City of Albuquerque

Environmental Health Department

To: Regan Eyerman, Senior Environmental Health Scientist
From: Jeff Stonesifer, Senior Environmental Health Scientist *JS*
Subject: Review of model for Albuquerque Asphalt, Inc.
Permit # 3291-M1, 1955, 1838

Figure 1: Planned layout of facilities and roads

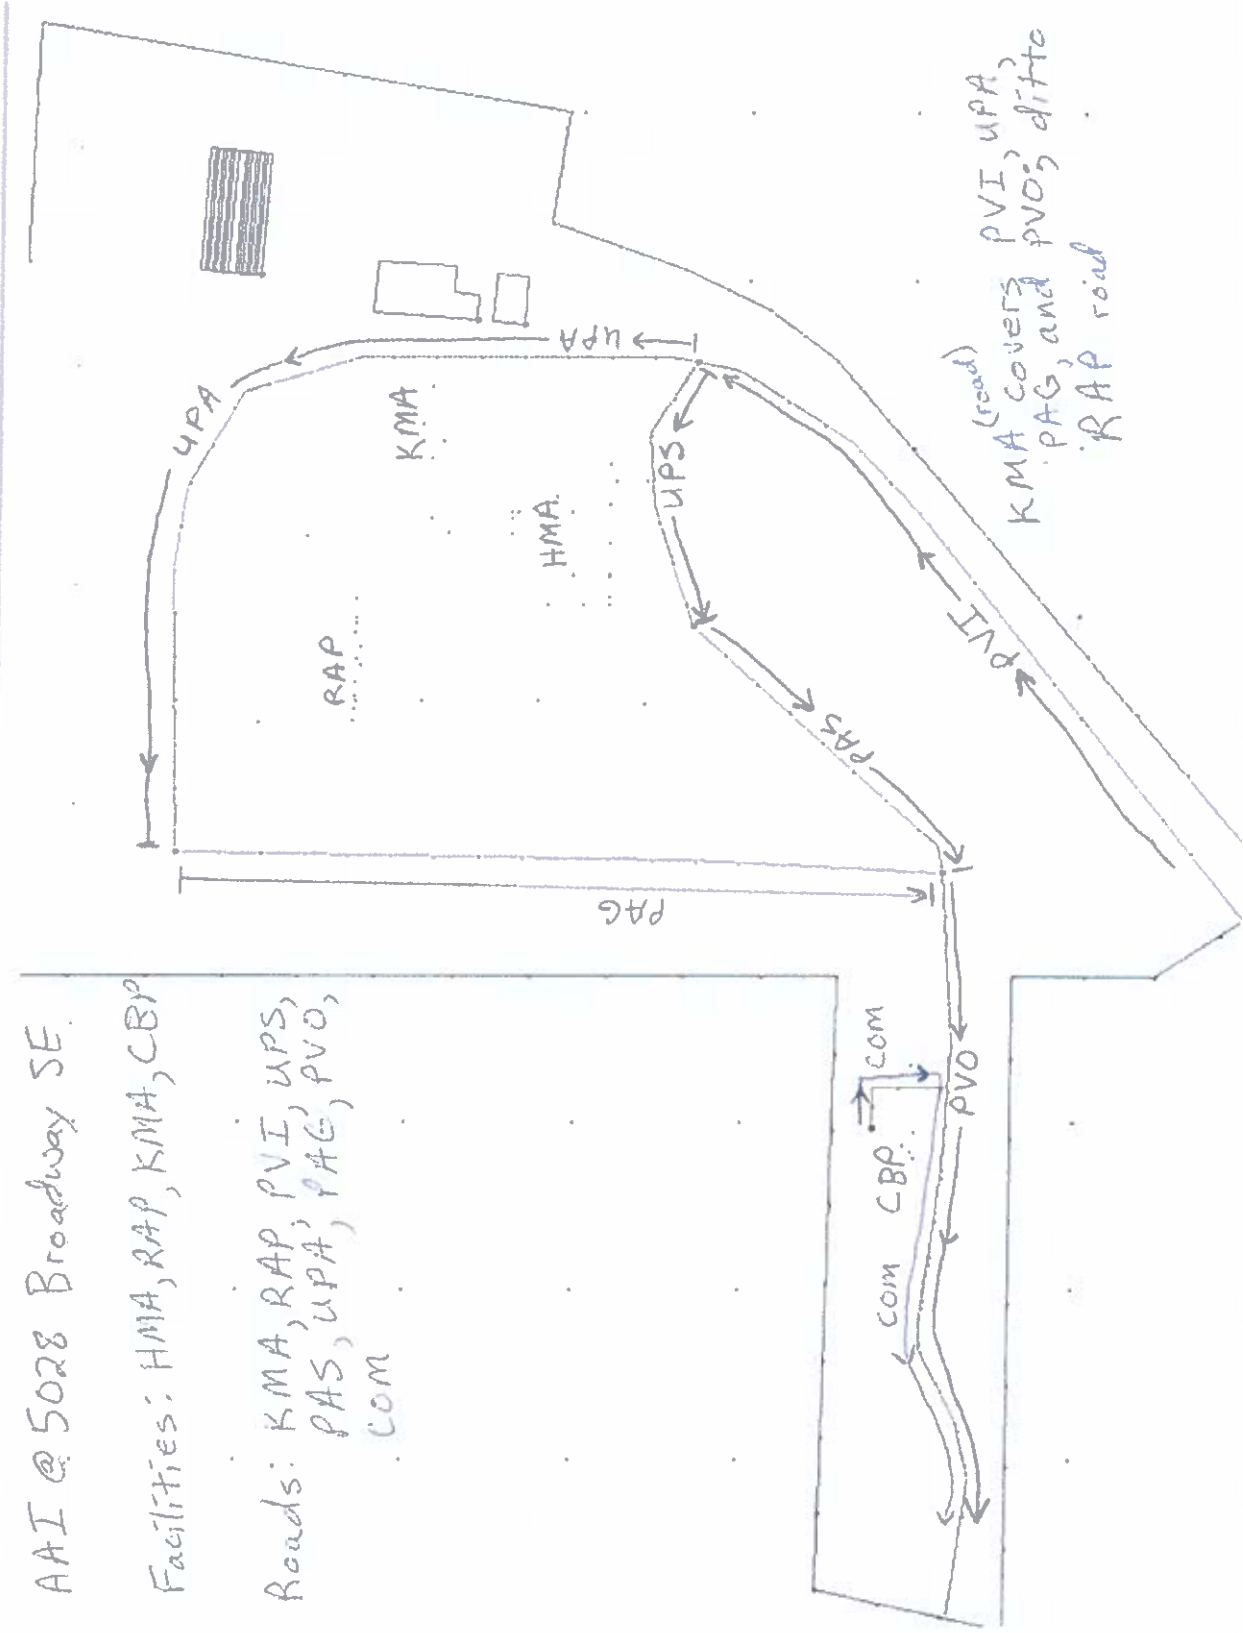
5. The following haul roads are paved. Refer to Figure 1 for visualization of haul road layout.
 - a. PVI, PAS, PAG, and PVO
 - b. COM...Concrete batch plant road
